**Final Supplemental
Environmental Impact Statement**

for the
BLUE RIVER-GORE PASS

portion of the
Hayden Blue River
Transmission Line Project
Colorado

DOE/EIS-0116-FS
Final Supplemental Environmental Impact Statement
for the
Blue River-Gore Pass Portion of the
Hayden-Blue River Transmission Line Project
Grand and Summit Counties, Colorado

Figure 1-1 Revised

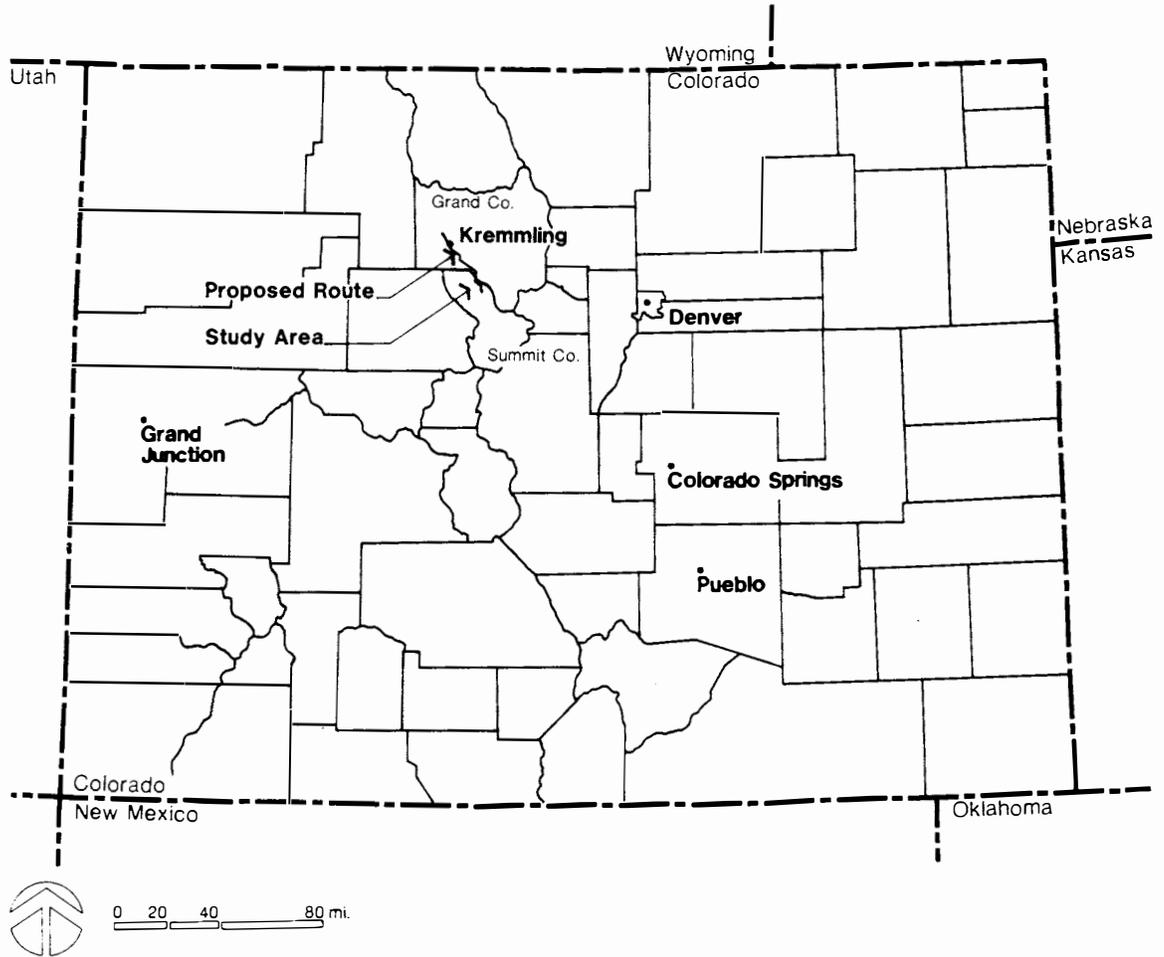
Western proposes to construct, operate, and maintain a new transmission line in north-central Colorado. The project region is shown in Figure 1-1. The line will be a steel lattice structure, single circuit, 345-kV line, initially energized at 230-kV. It will extend from the existing Gore Pass Substation, seven miles northwest of Kremmling in Grand County, to the proposed new Blue River Substation that will be located in Summit County near the Ute Pass Road about one mile from its junction with State Highway 9.

Figure 5-5 Revised

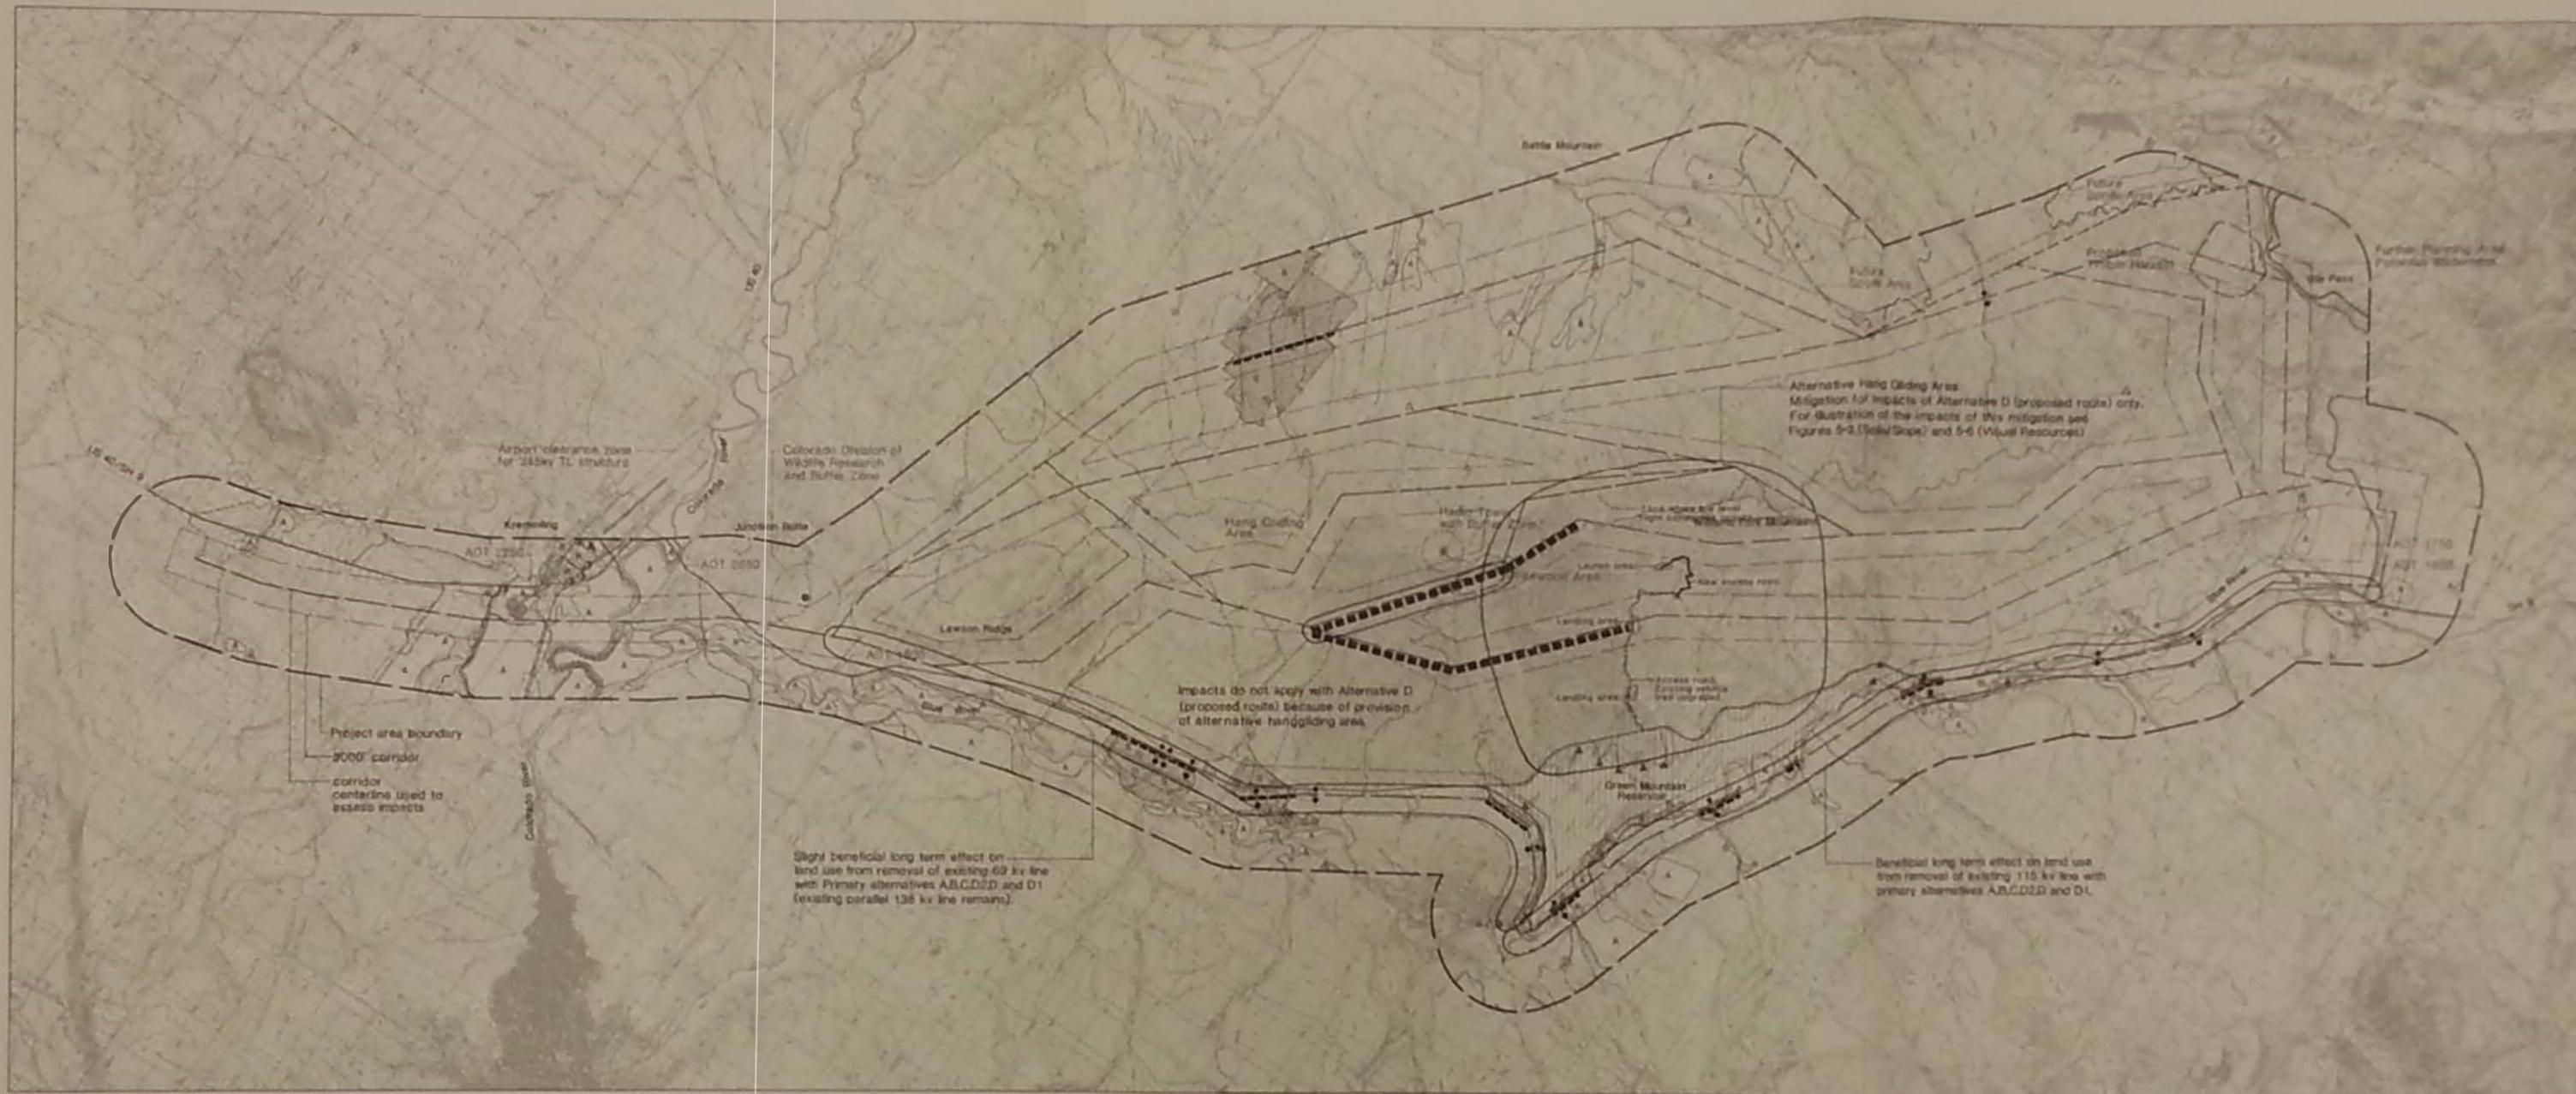
- C** 2. The Draft EIS fails to recognize long-term effects of the powerline on the CDOW research activities on the JBSWA (page 5-3, Table A-1, Fig. 5-5). The powerline will affect the research facility and activities for the expected life of the powerline and facility. The powerline will effectively curtail any planned expansion of the research pastures to the south and southwest because of right-of-way restrictions on development (page 3-13) and the limitations of research within such potential pastures that rely on radio-telemetry.

Figures 4-9 and 5-5 in this FSEIS show the hang glider flight area (zone where low level flight sometimes occurs) and the impacts of several of the alternative corridors on it. The environmental analysis in this FSEIS considers the impacts on the activity and proposes a measure to mitigate these impacts. The responses to Letters #14, #16, #17, #21, and #26 discuss impacts on hang gliding in detail.

As shown on Figure 5-5 in this FSEIS, the Proposed Route D, Primary Alternative D1, and those alternatives that use Link 16 (alternatives 13, 14, and 17; not primary alternatives) cross a hang glider area (zone where low level flight sometimes occurs) on the southwest slopes of the Williams Fork Range, resulting in significant impacts because the presence of the line presents a hazard to the activity.

The elements of this alternative hang gliding area are shown on Figure 5-5 in this FSEIS.

The Proposed Alternative passes through about 3.6 miles of a hang glider area (a zone where low level flight sometimes occurs). Because of the committed mitigation (the provision of an alternative hang gliding area, as shown on Figure 5-5 and described in Section C.5.(b)(2)), the impact of Route D on the activity is low. The only other sensitive land use condition affected by this alternative is agriculture. Two areas totaling about 1.25 miles in length are crossed by the corridor while paralleling an existing transmission line in the bottomlands of the Colorado River near Kremmling. The corridor also crosses a narrow band of cultivated land near the Ute Pass Road. Depending on when construction is scheduled, crossing these lands may result in short-term crop damages. Less than 0.5 acre of cultivated land would be lost as a result of the placement of new transmission structures. However, because some of the existing lines currently located within cultivated lands will be removed, the project's overall effect will be to reduce the amount of agricultural land precluded from cultivation. The alternative also passes through a designated firewood cutting area in the Williams Fork Range. This might result in the need to impose restrictions on cutting timber near the proposed ROW.

Figure 5-6 Revised
Visual Resources/Impacts

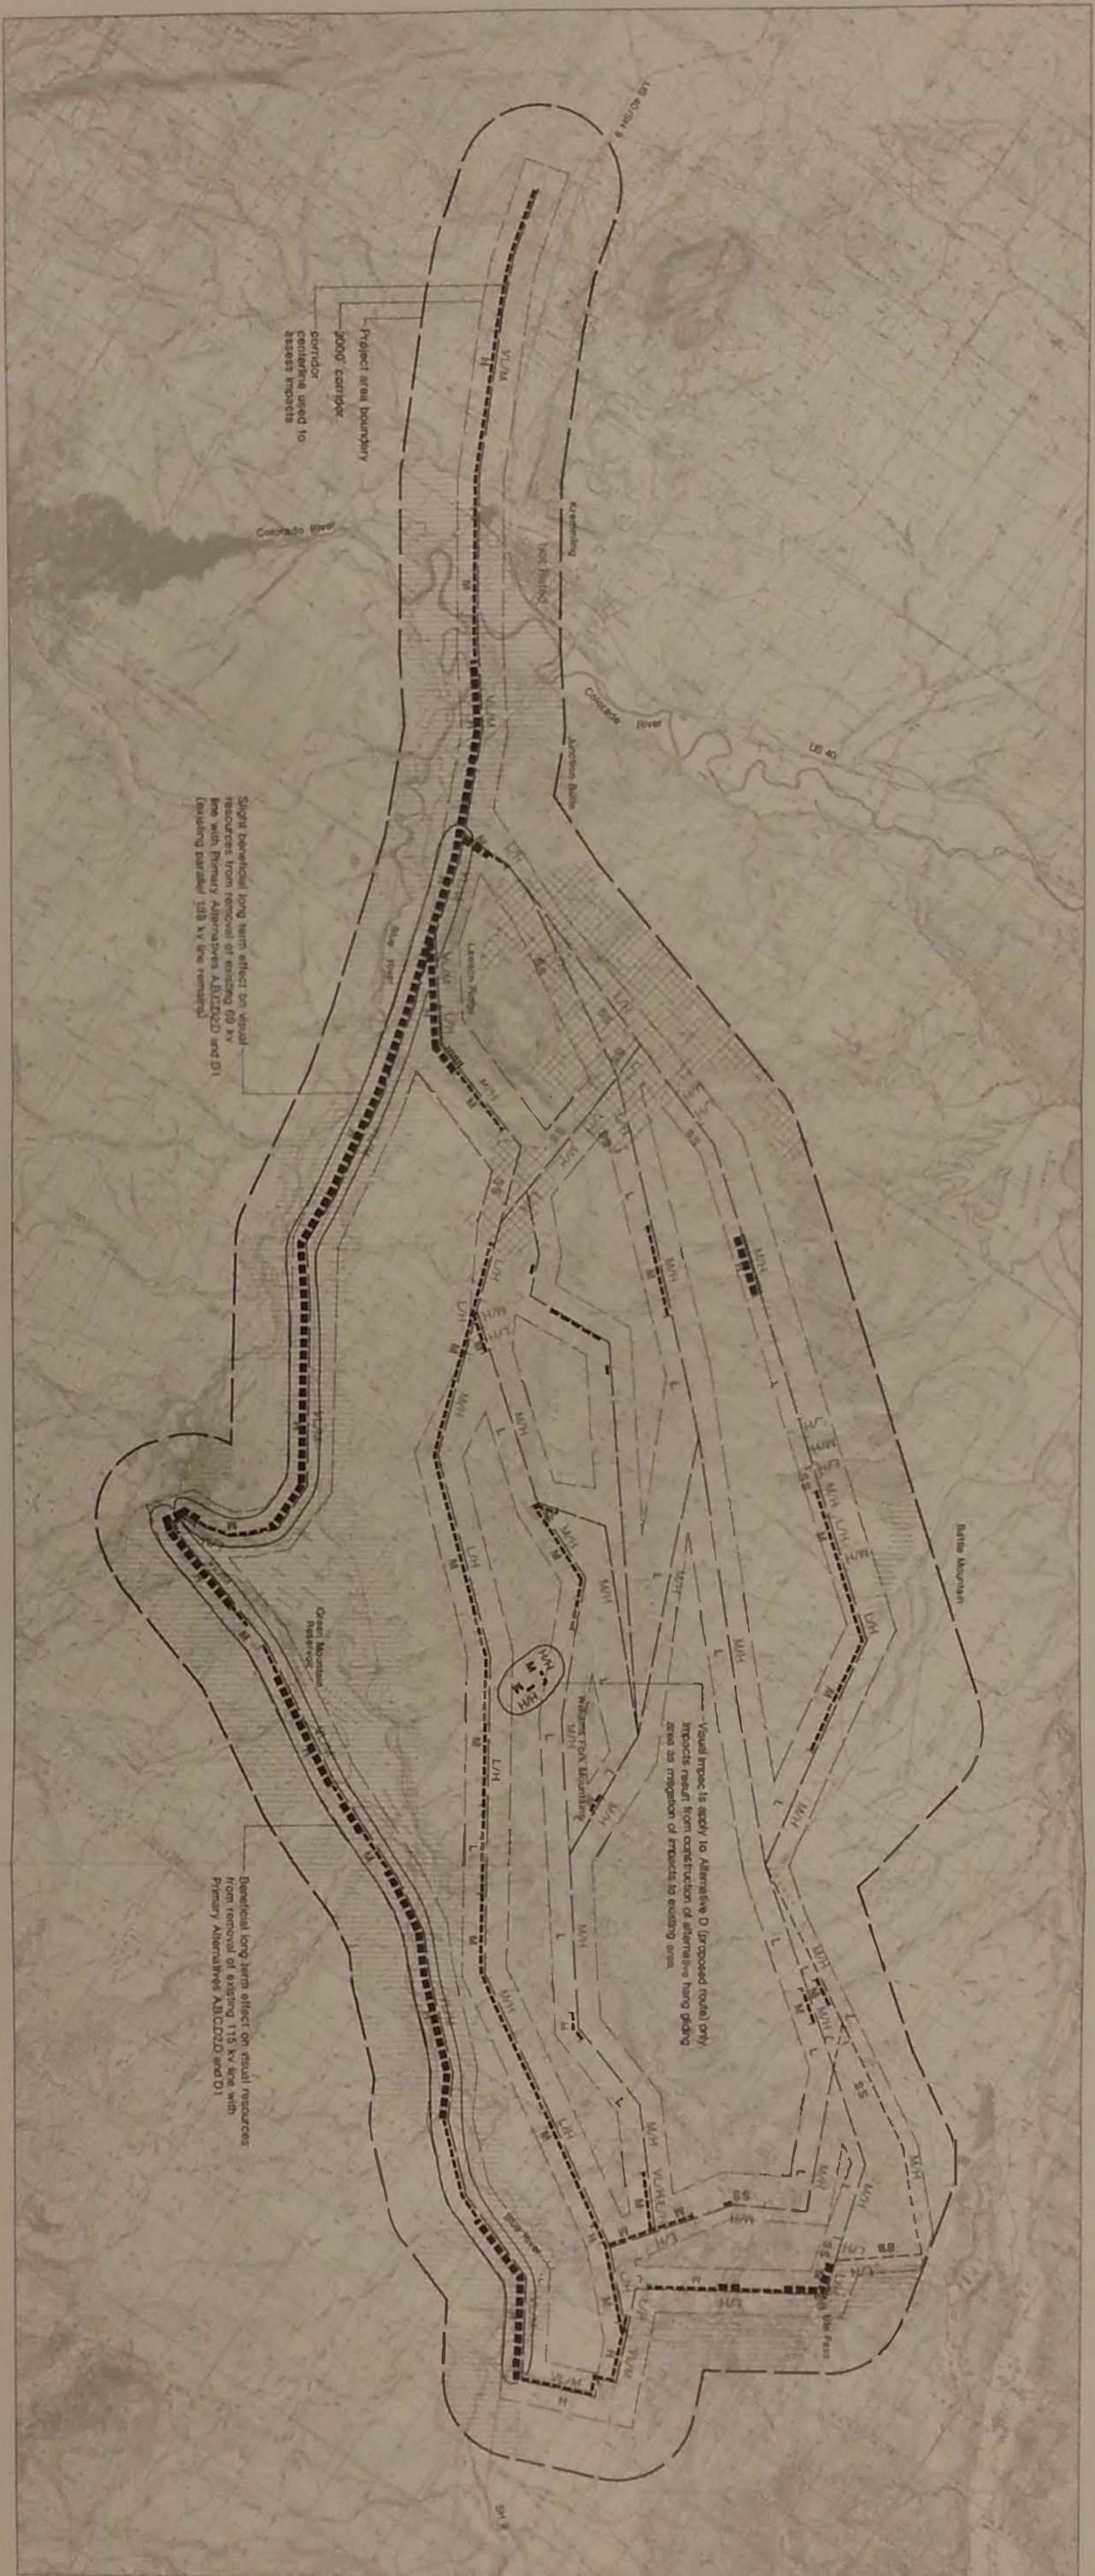
Two other commentators expressed concerns about the visual impacts the transmission line would have if it were located in the Williams Fork Mountain range. Visual impacts are addressed in detail in the DSEIS. Figure 5-6 (revised) in this FSEIS gives an overview of the visual impacts of all the potential corridors.

Figure 5-6 in the FSEIS shows the visual conditions impacted at moderate or higher levels by any part of the network of alternative corridors.

The appearance of this new corridor segment is illustrated in a photographic simulation from near the southwest edge of the Copper Creek subdivision (Figure 5-10b), in a perspective plot simulation from near the northeast edge of the same area (Figure 5-15a), and in a perspective plot simulation from Highway 9 two miles northwest of Willows Campground (Figure 5-16b). The visual impacts of the new line segment are included in the analysis and are, at worst, moderate where the line unavoidably crosses the skyline, as shown on Figure 5-6 in this FSEIS.
